EGG-PHY-8153

July 1988

TECHNICAL EVALUATION REPORT FOR THE EVALUATION  
OF ODCM UPDATED THROUGH REVISION 5  
JAMES A. FITZPATRICK NUCLEAR POWER PLANT

TECHNICAL EVALUATION REPORT  
for the  
EVALUATION OF ODCM UPDATED THROUGH REVISION 5  
JAMES A. FITZPATRICK NUCLEAR POWER PLANT  
NRC Docket No. 50-333    NRC License No. DPR-59

Figure 1. Liquid Radwaste Treatment Systems, Effluent Paths, and Controls for James A. Fitzpatrick Nuclear Power Plant. (Taken from Figure F-5 of the JAFNPP ODCM, Rev. 2 dated June 1985.)

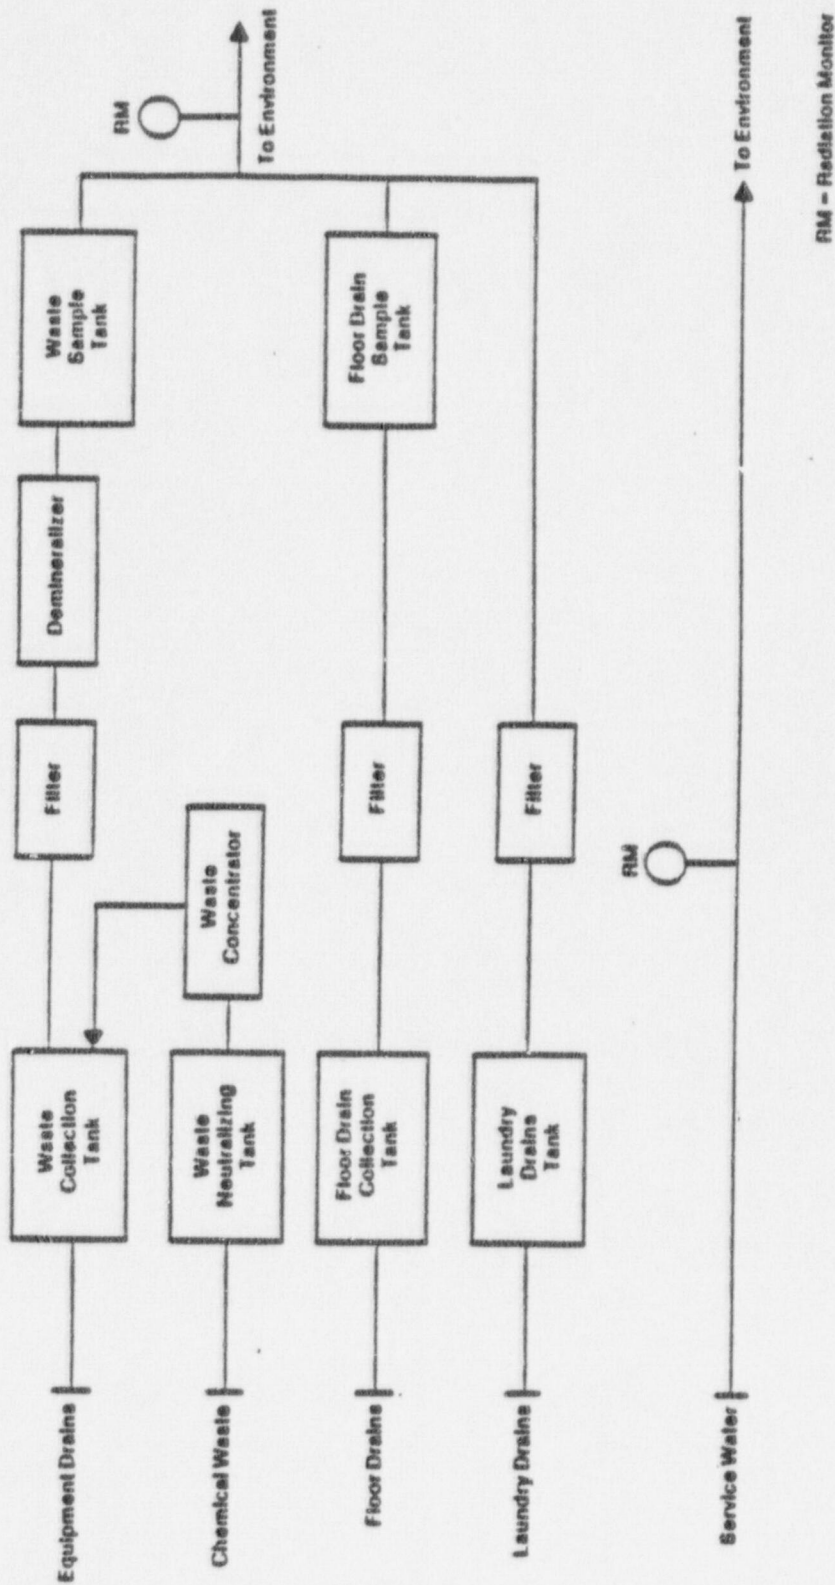
According to Figure F-5 of the ODCM (Figure 1 of this report) all

Liquid radwaste effluent meant for release passes through the monitored liquid radwaste effluent line. According to the text in the ODCM, the radwaste effluents are then diluted with the circulating water and service water before release to Lake Ontario. However, Figure F-5 of the ODCM does not show the point where the liquid radwaste effluent line joins the circulating water and the service water lines for dilution prior to discharge.

Figure 1. Liquid Radwaste Treatment Systems, Effluent Paths, and Controls for James A. Fitzpatrick Nuclear Power Plant. (Taken from Figure F-5 of the JAFNPP ODCM, Rev. 2 dated June 1985.)

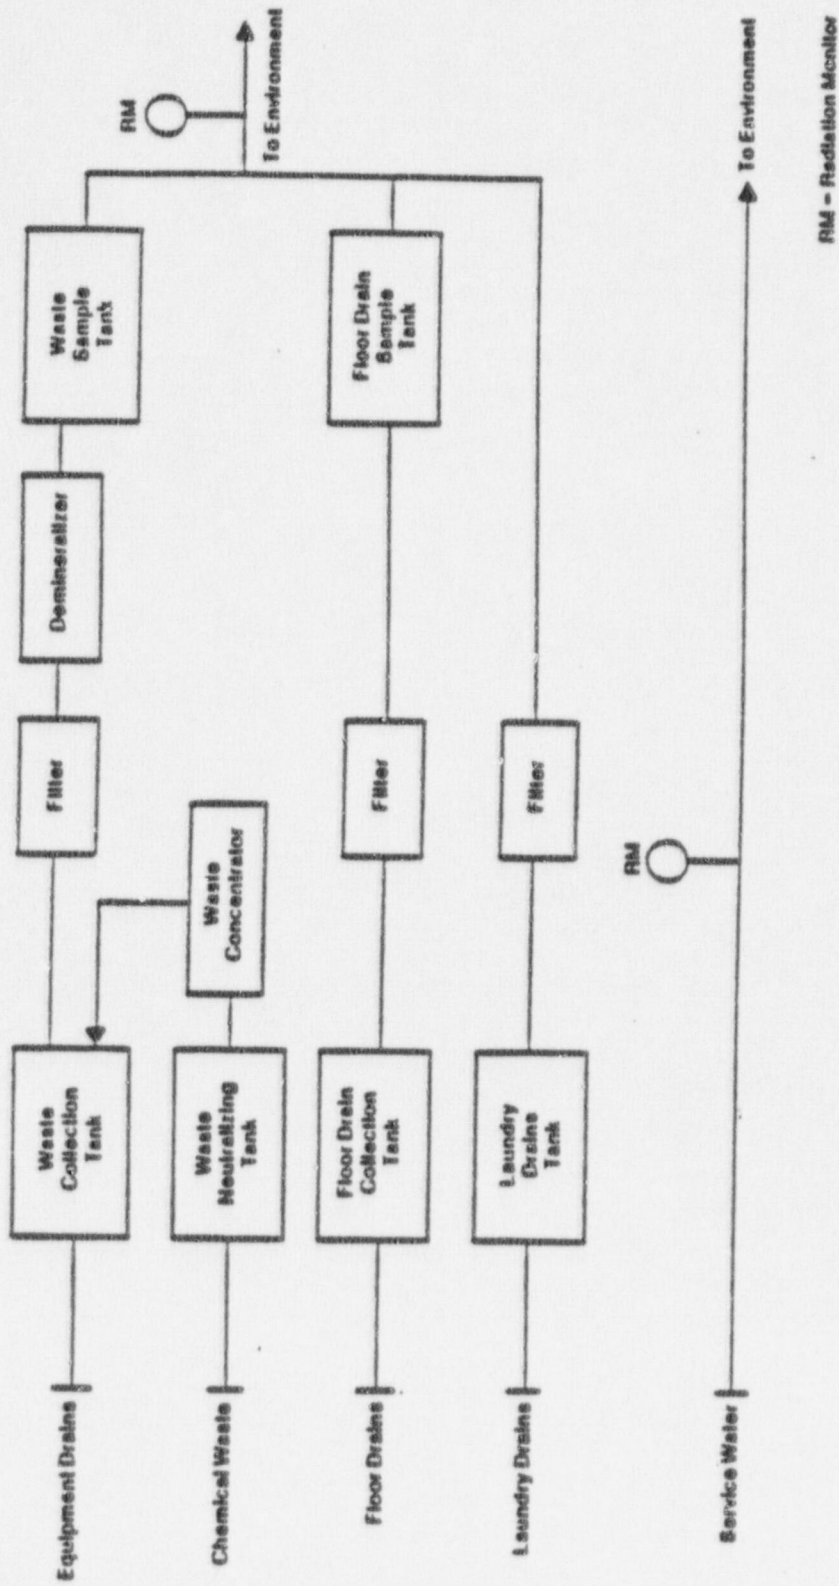
According to Figure F-5 of the ODCM (Figure 1 of this report) all

liquid radwaste effluent meant for release passes through the monitored liquid radwaste effluent line. According to the text in the ODCM, the radwaste effluents are then diluted with the circulating water and service water before release to Lake Ontario. However, Figure F-5 of the ODCM does not show the point where the liquid radwaste effluent line joins the circulating water and the service water lines for dilution prior to discharge.
